City of Sugar Hill
Planning Staff Report
DRB-CBD 22-002 / VAR 22-002

DATE: March 31, 2022
TO: Mayor and Council, Design Review Board
FROM: Planning Director *KA*
SUBJECT: Central Business District (CBD) design review and variances.
DRB CBD 22-002 / VAR 22-002
Stanley Street extension, residential component of phased mixed-use development.

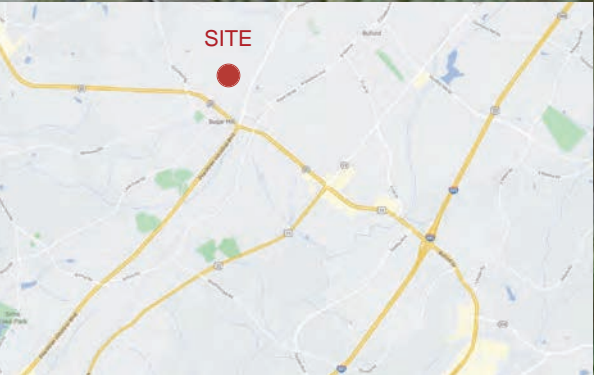
The proposed elevations and conceptual site plans are compatible in scale, material selection, and general design character with the nearby development.
